Capturing Jitter Penalty with TDECQ and FRx

(Comments 124, 125, 126, 127, 128)

Ali Ghiasi - Ghiasi Quantum/Marvell

IEEE 802.3dj Interim Meeting
Austin

PMA-PMA Jitter Transfer and Penalty

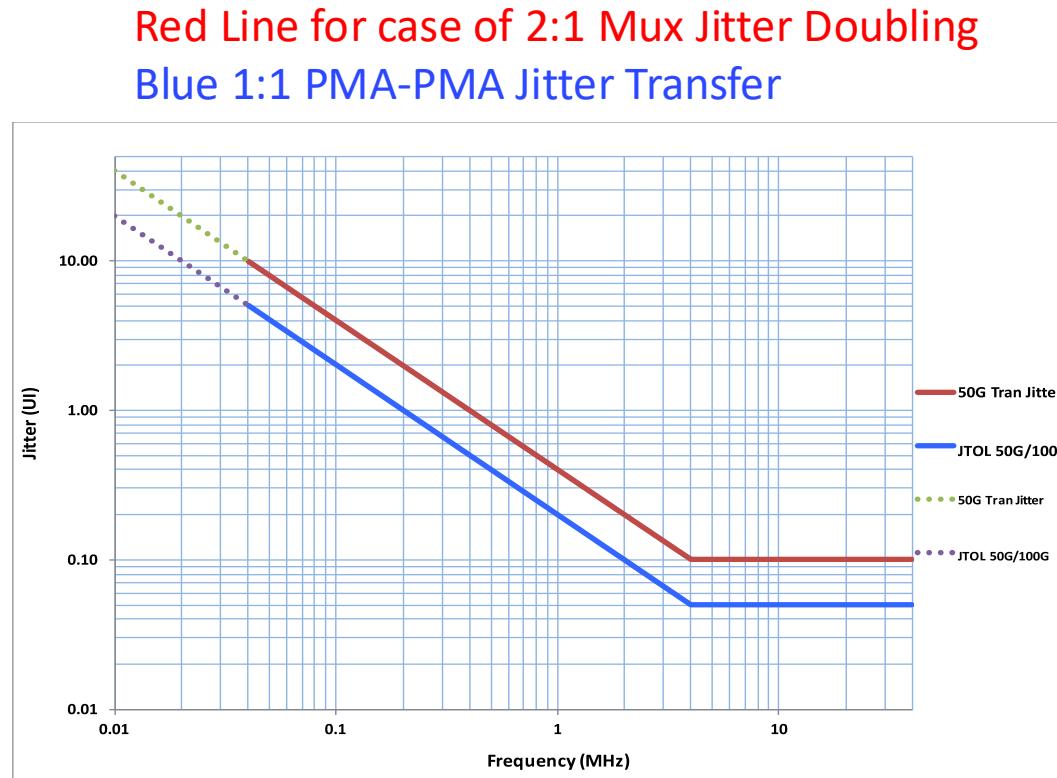
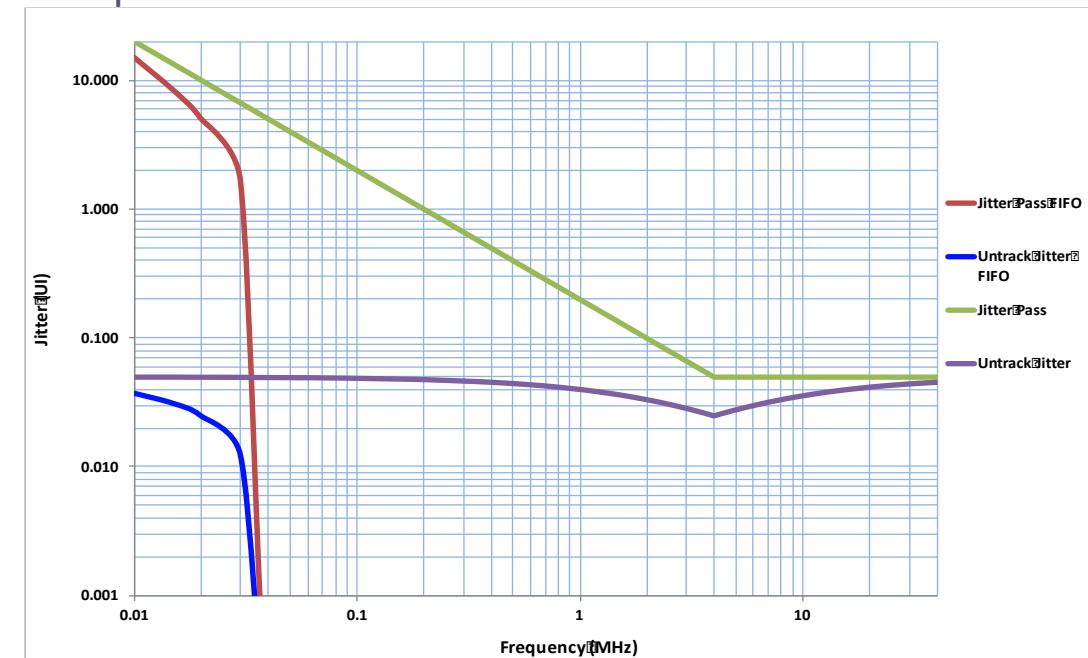
- ❑ PMA-PMA implementations such as BW, peaking, and FIFO has significant impact on jitter transfer
 - With benign signal applied to xAUI-n penalties to jitter from xAUI-n and jitter peaking are masked from TDECQ/FRx
 - For detail of jitter transfer graphs below see [ghiasi 3cd 01 0118](#) .

Red Line for case of 2:1 Mux Jitter Transfer with FIFO
Orange 1:1 PMA-PMA Jitter Transfer
Purple Untrack Jitter for 2:1 PMA with FIFO

Current TDECQ/FRx Jitter Shortcoming

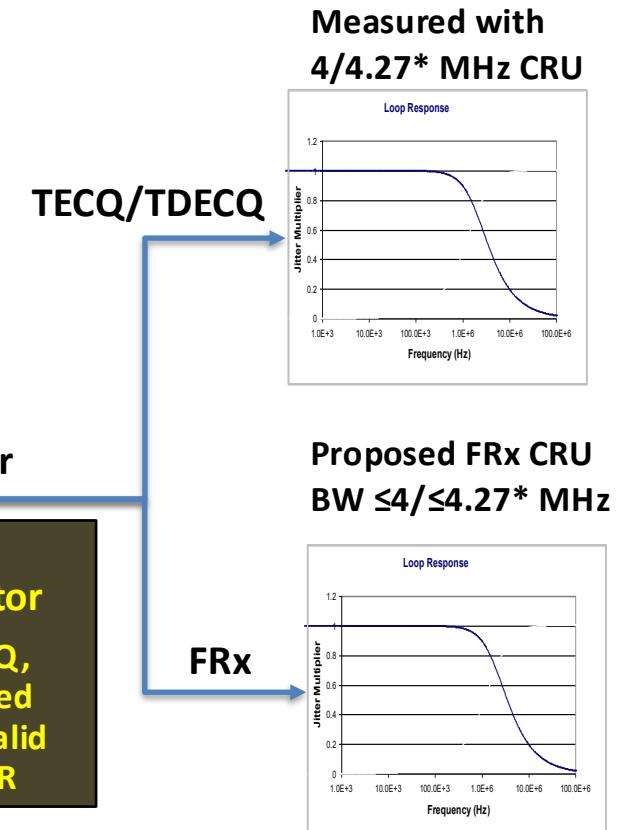
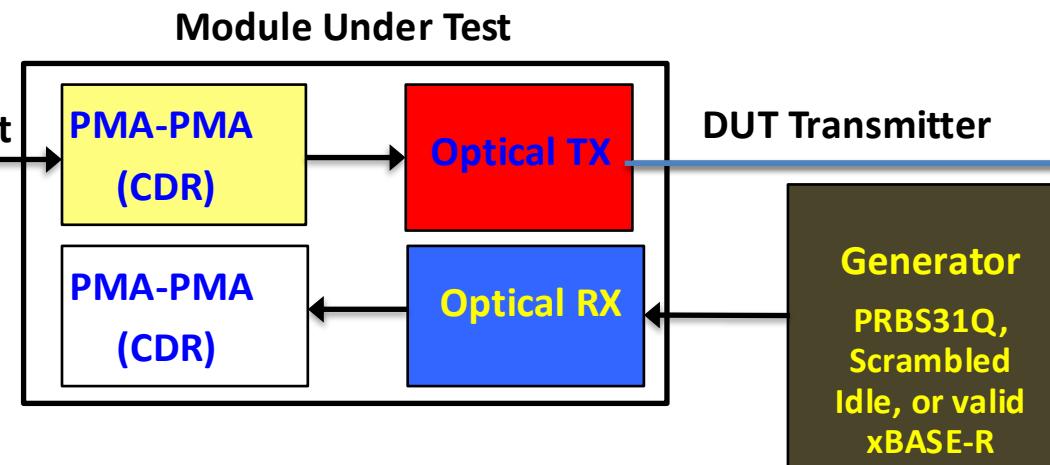
Module under test TECQ/TDECQ and FRx results are depended on how well DUT test setup captures worst case allowed jitter

- The highlighted module PMA-PMA may have variety of responses such as:
 - May have BW <4 MHz
 - May have BW >4 MHz
 - May have few dB's of jitter peaking
 - In case of 2:1 PMA integrated jitter may double
 - May include FIFO where xAUI-n jitter is attenuated
- Depended on the module PMA implementation TECQ/TDECQ/FRx may have sensitivity to one or more of the JTOL test frequencies!

Proposed Remedy See comments 124, 125, 126, 127, 128

- Add following sentence to include JTOL test condition to 180.9.6, 180.9.9, 181.9.6, 182.9.6, 183.9.6**
 - For those cases there is a xAUI-n chip-to-module (C2M) interface TDECQ must be met with Module stressed input condition in 176D.8.14 for 200 Gb/s AUI and in 120G.3.4.3 for 100 Gb/s AUI
- The proposed remedy did not want to require testing at all 8 JTOL test frequencies**
 - Generally, for a given DUT PMA/Module one of the JTOL frequencies may result in maximum penalty at TP2
 - Manufacture may choose to test at one frequency or may determine even testing without the JTOL condition present for a specific PMA-PMA device there is negligible jitter transfer penalty .
